Re: Third Party Review – Quesnel-Hydraulic Road/Slide

Independent Review of Feasibility of Temporary Access Quesnel-Hydraulic Road landslide

Quesnel, BC

20397030-001-R-Rev0

Figure 1: Toe Erosion by Quesnel River

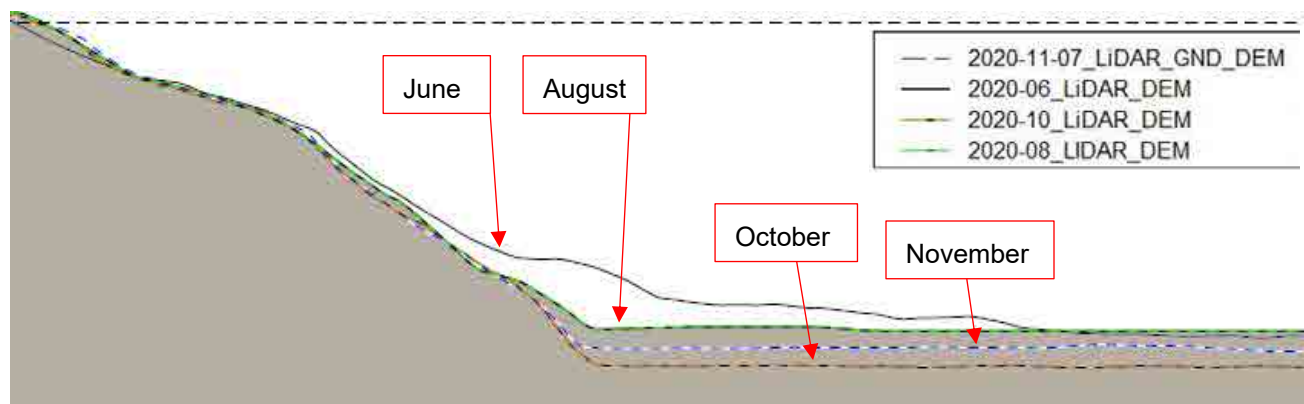
Figure 1 shows the main landslide debris as present in June 2020 and then becoming eroded over the summer and fall of 2020. The slide debris/river bank is eroded about 10 m horizontally and up to 2 m or more vertically.

- MoTI completed additional change detection using LiDAR collected in October and November 2020 which showed similar movements of the overall landslide and along the three landslide paths (Slide B, E and G) with backscarps evident up to approximately 300 m horizontal distance from the river. In addition, significant toe erosion along the outside bend of the Quesnel River extending from the farmers field to the south of the Q-H Site near Slide G and extending to Slide B. The debris from Slide B that was deposited in the Quesnel River in May has generally be eroded by the Quesnel River by the November 2020 LiDAR as shown in Figure 1.

Golder's stability analysis showed that continued erosion by the Quesnel River would result in slightly reduced FoS and likely additional landslides. Figure 1 shows that landslide debris and toe erosion was significant over the period of June to August and then continues to the last LiDAR data in November. Landslide movement appears to be correlated with toe erosion as discussed in MoTI 2020 in Appendix B and shown in the Golder slope stability modelling in Appendix D. Typical toe erosion control measures such as riprap would involve encroachment into the Quesnel River and are not acceptable to MoE at the current time. Other erosion control measures such as a secant pile wall are not possible to construct with locally available equipment. Golder does not believe that it is possible to construct a road at this time, using the resources specified, given that the road needs to have a lifespan of 1 to 2 years. Simple grading earthworks within the slide mass are not sufficient to stabilize the slope. Protection of the toe from erosion by the Quesnel River is not feasible with the limitations indicated. Further, it is likely that some drainage scheme, in combination with toe protection and berming, will also be necessary to both increase the overall FoS and to minimize the occurrence of small localized failures.

Figure 6: Slide F Model Section- Stratigraphy

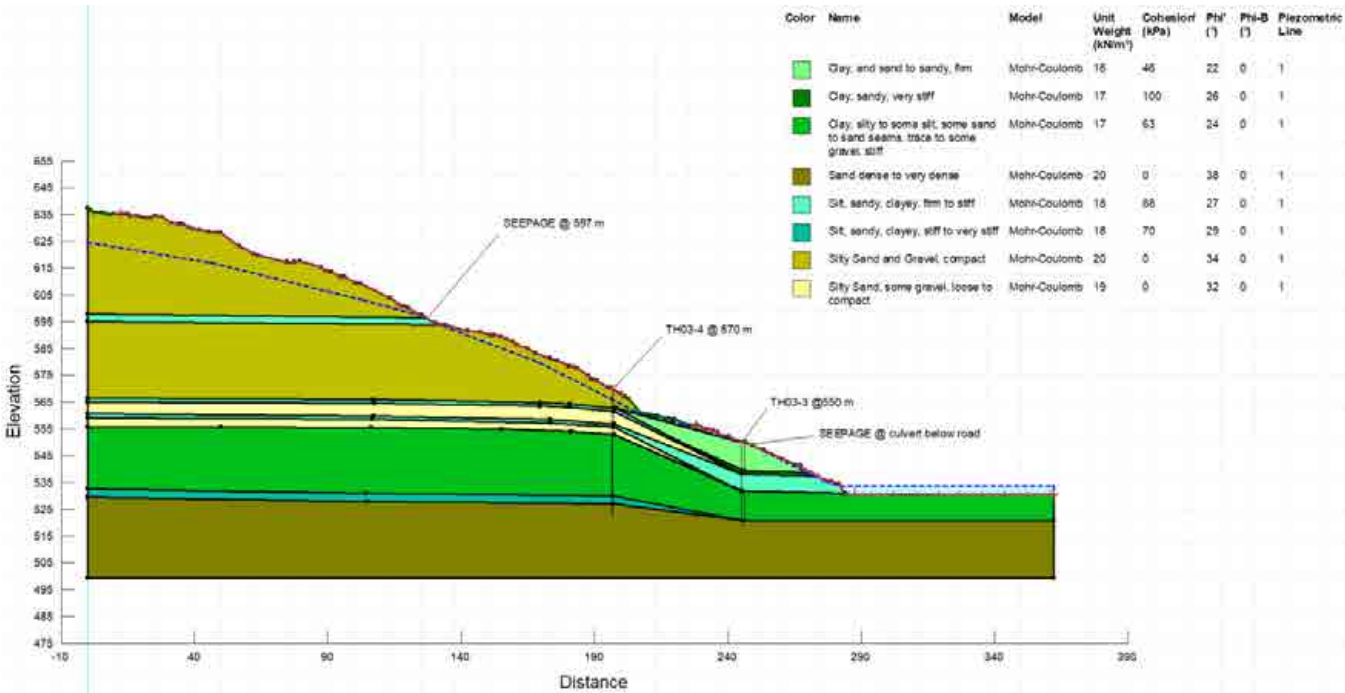
Soil information used to develop Slide F model section was compiled based on historical data from test holes TH03-3 and TH03-4 reported in GeoNorth (2004). The test hole data was plotted downhole through the cross section and similar soil types were connected between boreholes. Where similar soils were not present between boreholes Golder assumed the stratigraphy “pinched out” throughout the entire horizontal distance between the two boreholes. The stratigraphy was assumed to be relatively horizontal both up and downslope of the boreholes because the geological history of the area indicates glacier retreat leaving ablation till, lake sediments and meltwater channel deposits. A sandy silt layer of firm to stiff consistency was drawn in the model at approximately 597 metres above sea level (masl) based on visual observations during the reconnaissance. Site-specific groundwater table elevations are not available at this time. A likely scenario of the phreatic surface was approximated to daylight at the observed seepage zone near the top of the slide (597 masl) and then persist underground throughout the rest of the slide area, daylighting again at river elevation. For the purposes of the model the water table is approximately equal to the phreatic surface. The Slide F model cross-section and stratigraphy can be seen in Figure 6.

Figure 7: Slide B Model Section - Stratigraphy

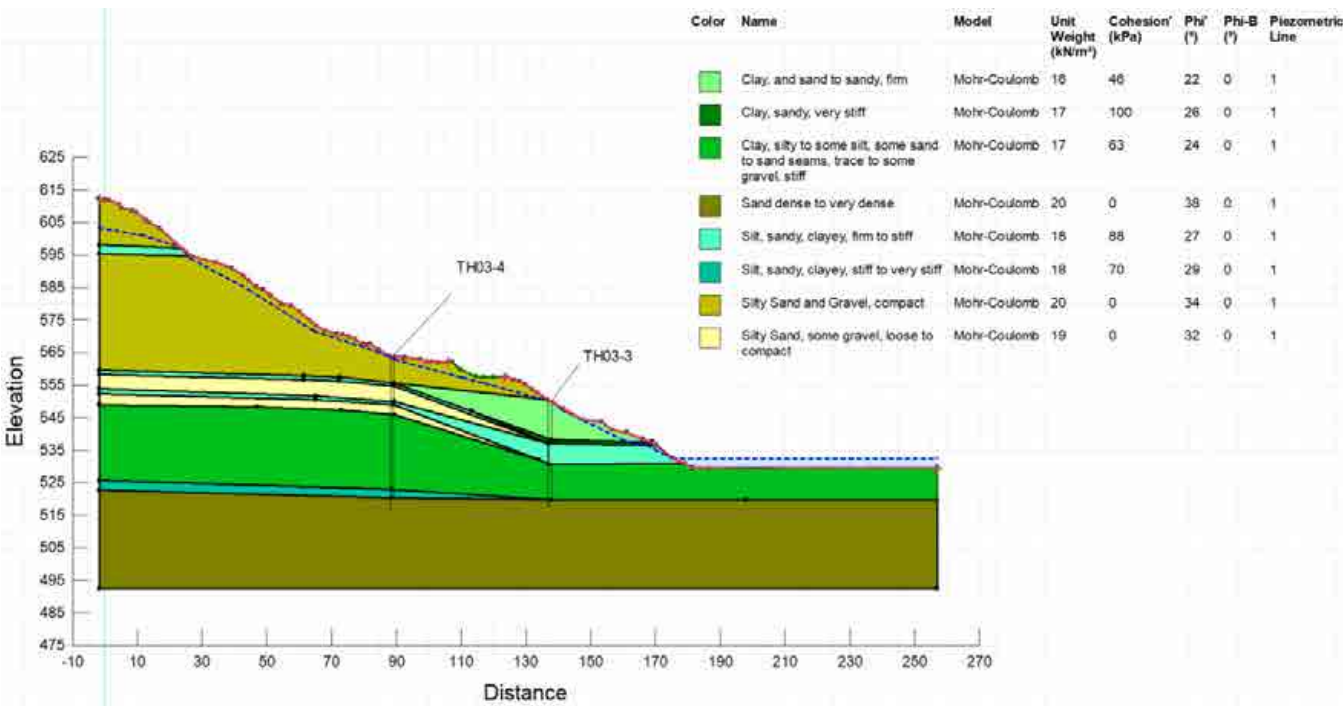
Site-specific drillhole data was not available for Slide B. Therefore, the soil stratigraphy for the Slide B model was based on a projection of the stratigraphy from the Slide F model section. The Slide B model cross-section and stratigraphy can be seen in Figure 7

DRAWN BY: S.Ruiz	PROJECTION: UTM Zone 10	SCALE: AS SHOWN
CHECKED BY: W.Lemky	DATUM: NAD83	DATE: 16 September 2020
FILE No. 20.3kmslide_fig1_orthoobligue_2020-09-16.dwg	PROJECT No. 18-SS-1242	REG. NR
	DRAWING No. Figure 1

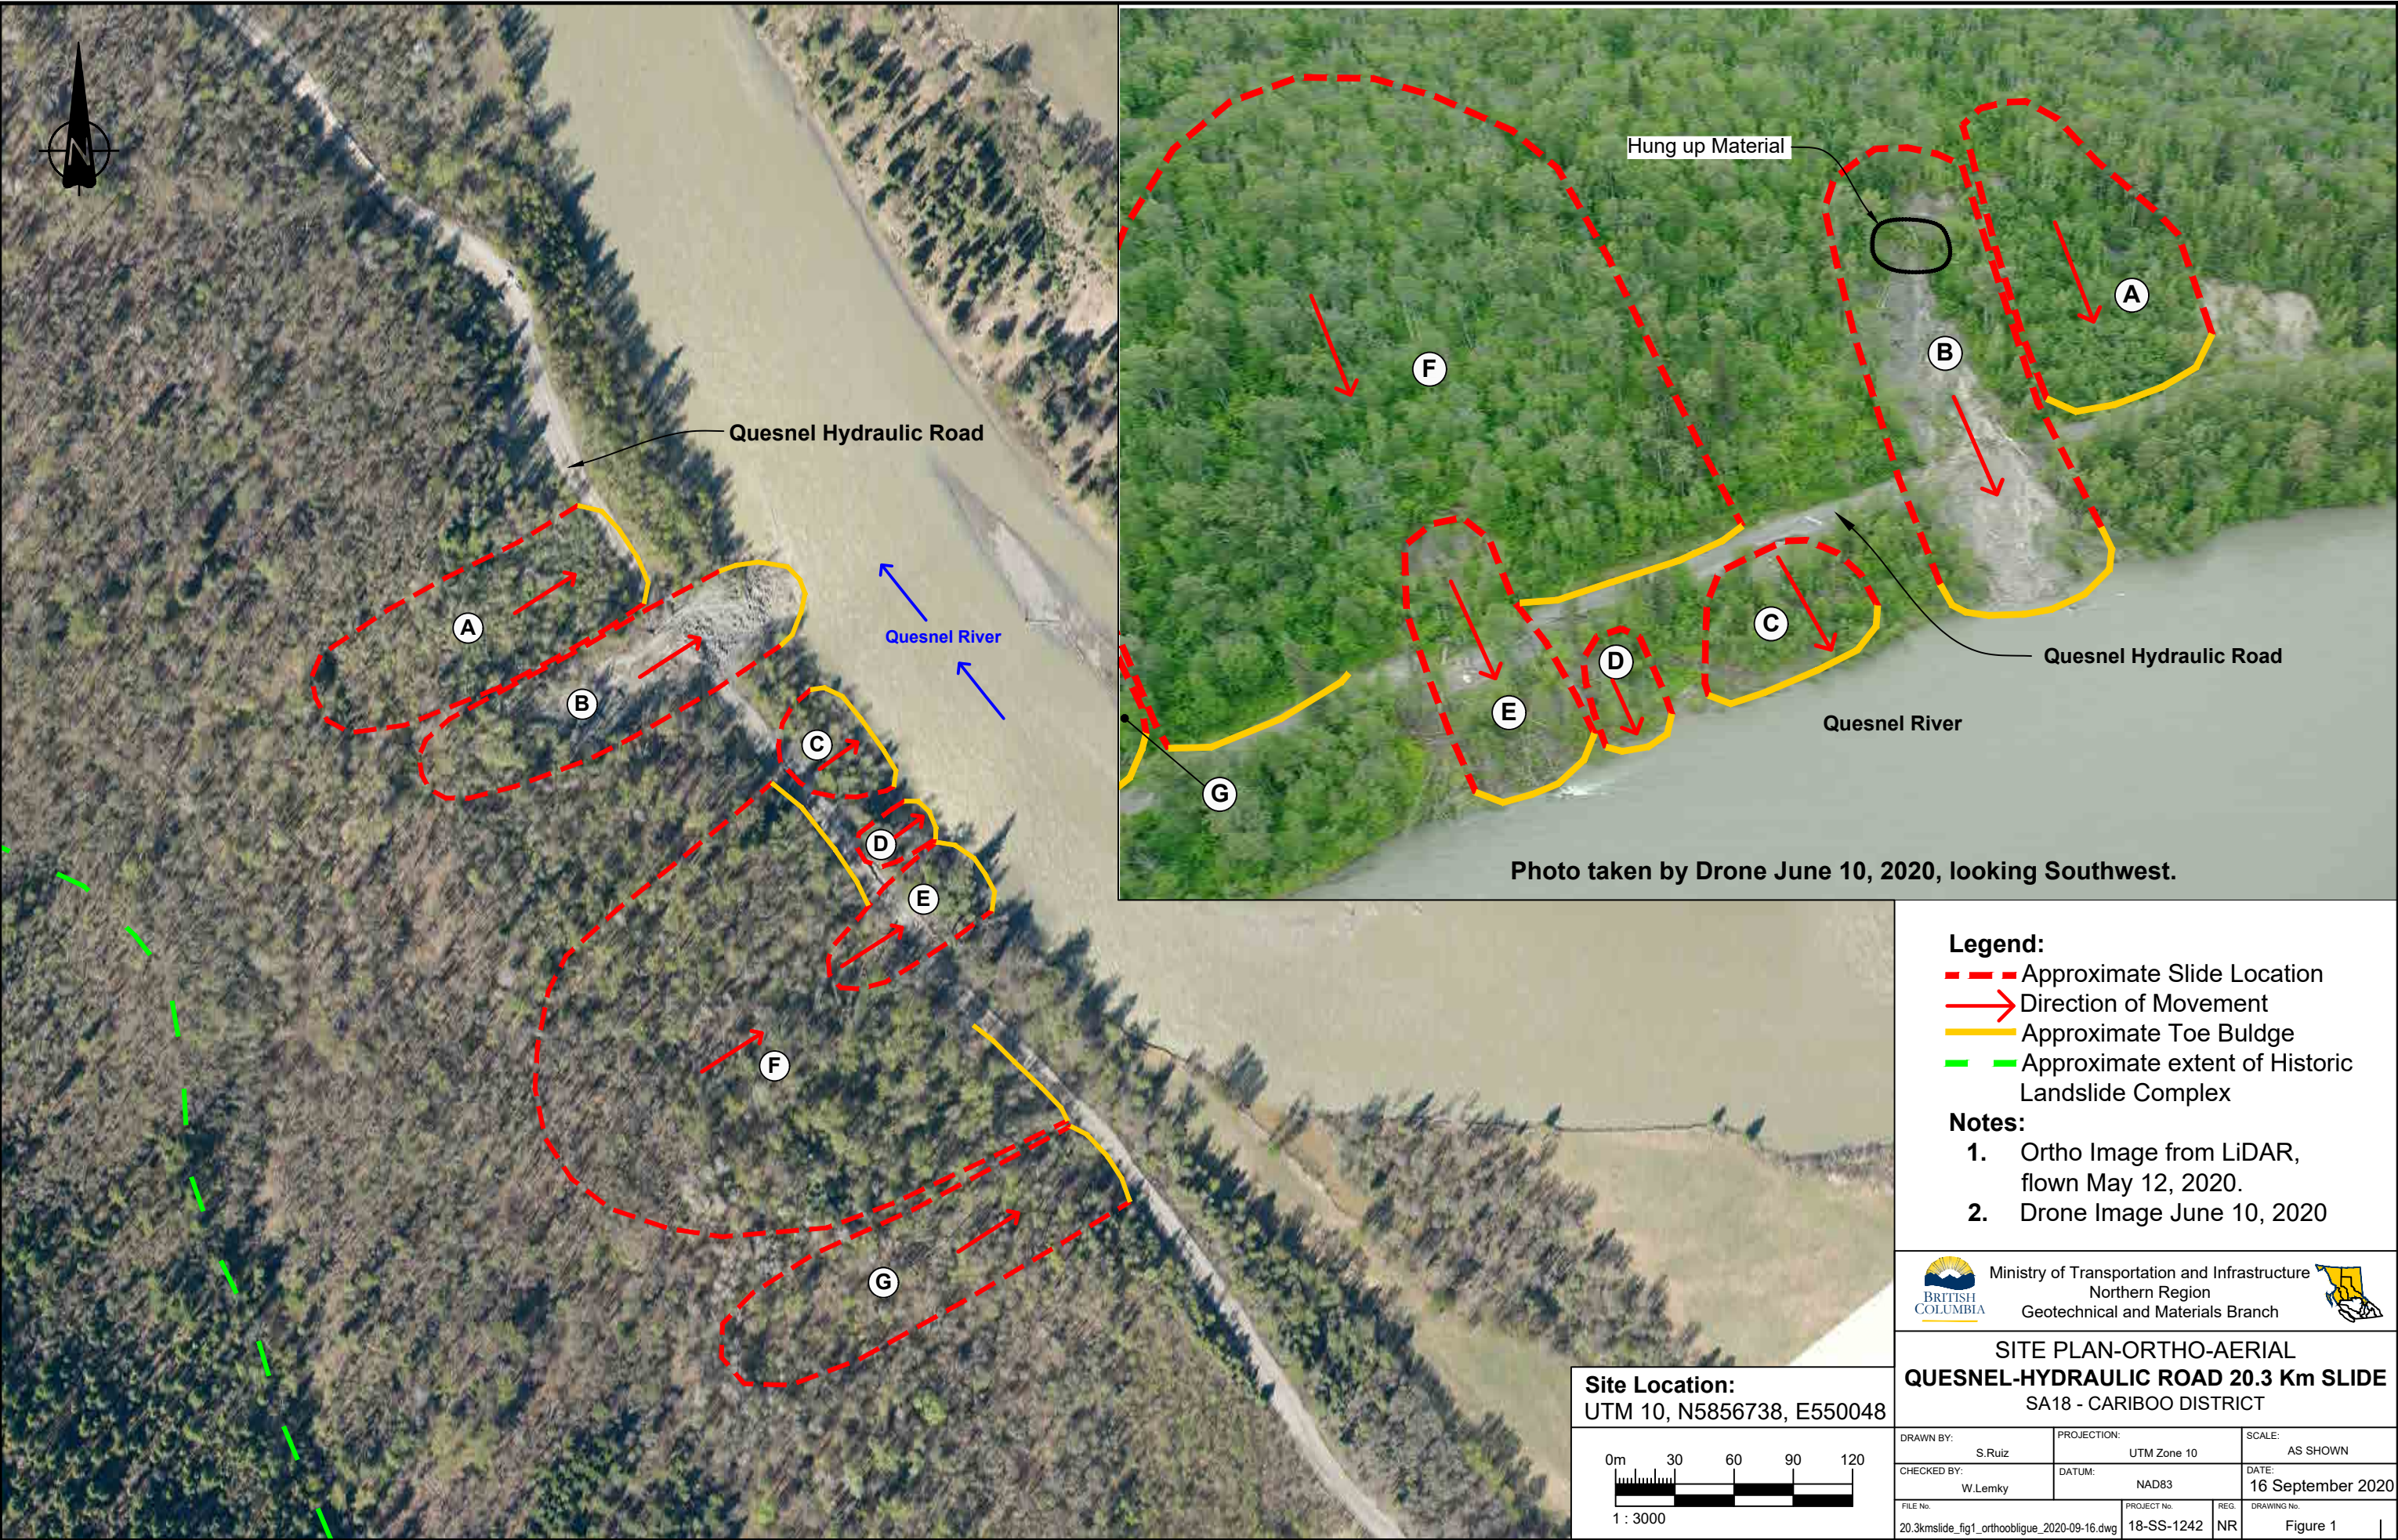
- The slide is hypothesized to consist of up to seven (7) smaller slides labelled A (northern most slide) through G (southern most slide) as shown on the MoTI Figure 1 in Appendix C. There are 12 cracks (labelled 1 through 11, including crack #6 and #6-2) that have been identified throughout the slide area and marked with GPS waypoints as shown on the MoTI Figure 2 in Appendix C.
- Cracking in the roadway was observed near slides D and E on 15 April 2020. By 25 April 2020 the roadway had become unsafe for safe vehicle passage and was subsequently closed to traffic. On 1 May 2020 Slide B failed across the roadway with a second slide in the same area on 4 May 2020. Around 4 May 2020 Slide C accelerated, and the roadway dropped down by more than 2 m.

By 1985 photo, there appeared to be evidence of significant landslide that was not visible in the 1980 photo. A track, cleared of vegetation, could be seen on the downslope side of the road, running directly into the river. This main track was near the Slide B path identified by MoTI. No significant vegetation loss upslope of the road was identified; however, a gully feature was noted directly upslope of the inferred debris path. This gully feature appeared to drain a small wetland/pond area further upslope and south of the slide path. Other, smaller clearings downslope of the road, north of the Slide B path were visible. However, these clearings did not extend down to the river. Some clearing upslope of the road near the Slide A was noted, indicating potential recent slope deformation. An area of exposed soil upslope of the road, north of Slide A was visible, with debris noted downslope of the road. This specific area is inferred to be the exposed soil slope seen to the right of Slide A in MoTI's Figure 1 in Appendix C.

Slide B on MoTI Figure 1 was observed in Photo 1 to have displaced a significant amount of debris into the Quesnel River as shown on Photo 2. Water with grey silt was observed flowing over the slide debris. Some saturated, very soft zones with sand and silt were noted, making travel over the debris difficult. Rounds of wood had been placed over the slide debris in spots indicating that the ground is/was very soft.

From the area between Slide A and Slide B, the landslide paths were observed and the top of the “hung up material” observed in Photo 1 and shown on MoTI Figure 1. The “hung up material” was estimated to be approximately 8 m to 10 m below the main backscarp as shown in Photo 10. The soils observed above this “hung up material” appeared to be clay/silt overlain by sand. The clay/silt appeared to have some water on it and ice was observed within the sand indicating that likely water is flowing at the interface between the clay/silt and sand.
